## M120.0 BevMax 4/3/2 High Security Door Latch

**Models affected:** All DN5800/3800 BevMax 4/3/2 Venders.

**Reason:** To enhance the security of the Service Door in DN5800 Venders.

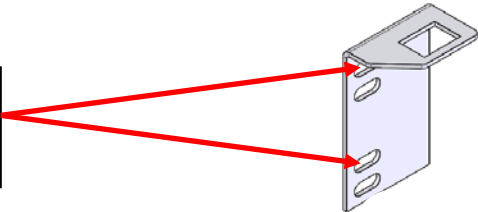
Use top set of holes for highest lock bar engagement.

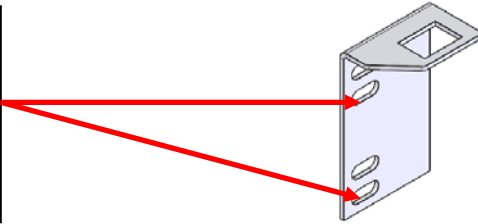
At the top position you will need to use the bottom set of holes to allow clearance for some peripherals. Example: Currenza Recycler.
